SHOREHAM NUCLEAR POWER STATION

SNRC-605

SHOREHAM NUCLEAR POWER STATION - Unit 1
Docket No. 50-322

HUMAN FACTORS ENGINEERING
CONTROL ROOM DESIGN REVIEWLILCO RESPONSE TO NRC AUDIT FINDINGS
SHOREHAM NUCLEAR POWER STATION - UNIT 13. ANNUNCIATORS AND AUDITORY SIGNALSNRC Finding 3.1

Div. II Section of H11-P601

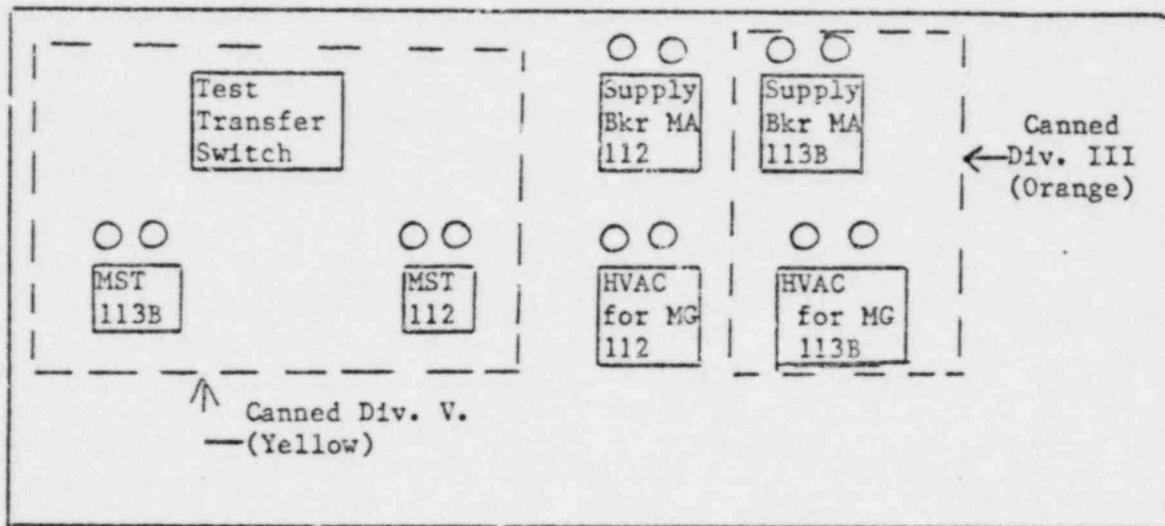
Transfer switch MST 113B and related switch MG 113B are separated by switch 112 and a breaker. Similar arrangements are found for switch 111 and switches 113A. (2)

The layout was designed for electrical separation. See diagram below:

LILCO will reverse switches MST 112 and 113B and provide color pad enhancement for the entire switch cluster diagramed above. A similar change will be accomplished for Division I switches on panel 601. This will be accomplished prior to fuel load.

SHOREHAM ADS SYSTEM COLOR PADDING

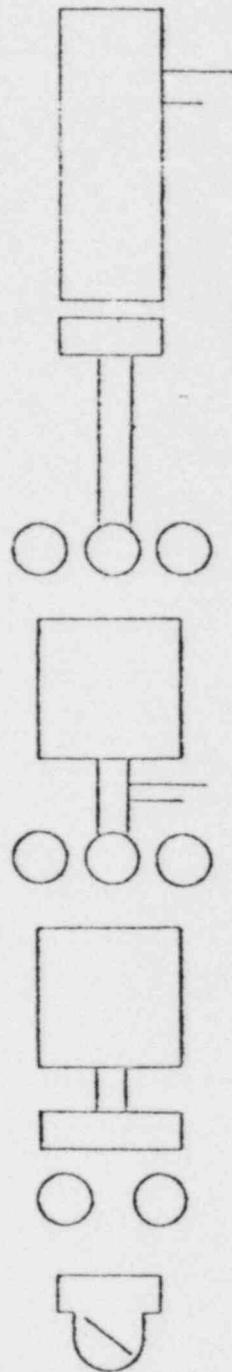
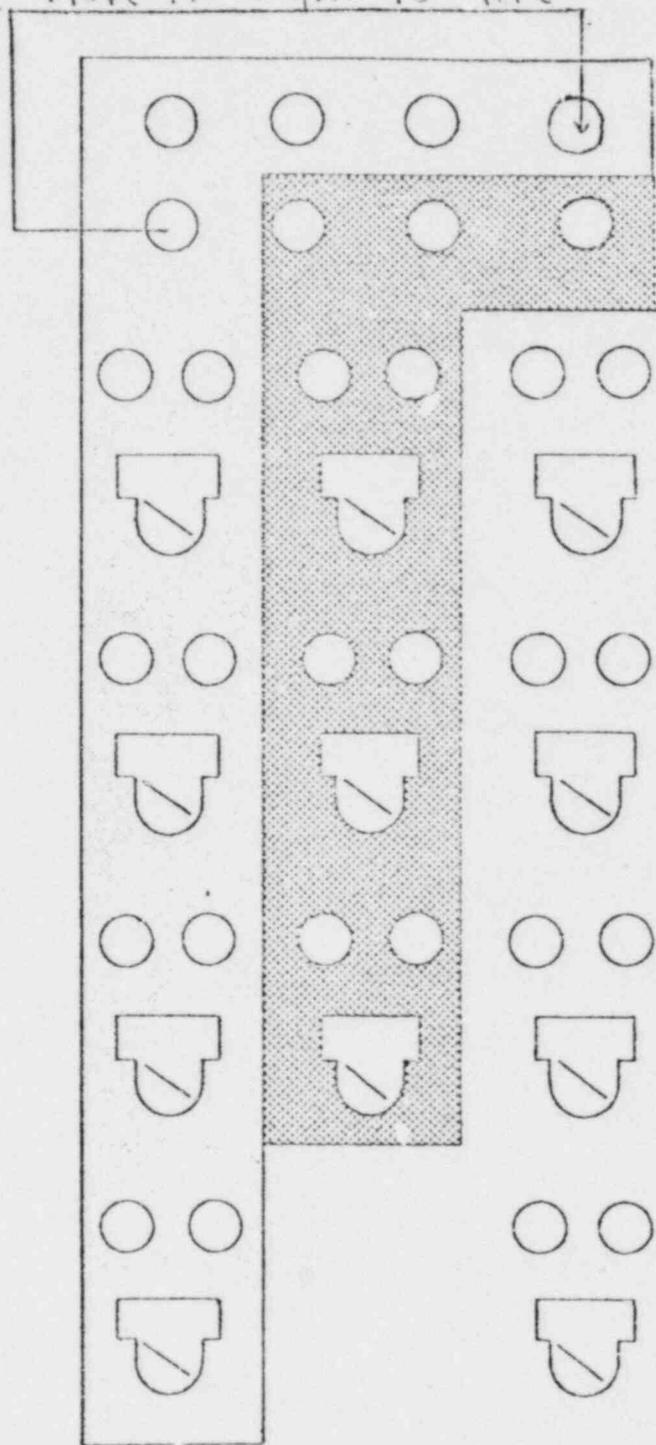
On Panel 602 there is an inconsistent relationship among the valve switches and the corresponding indicator lights in both position and orientation. (1) (9.1)

The NRC finding is concerned with the relationship of the switches associated with the ADS and Safety Relief Valves and the corresponding indicator lights. LILCO has identified this problem in their preliminary assessment report as item 9.1. The ADS system will be enhanced through color padding to improve the switch/indication relationship (see enclosure 2). The B solenoid red indicating light for the SRV "H" will be relocated as shown on enclosure 2. This will be accomplished prior to fuel load.

Move "H" light to here
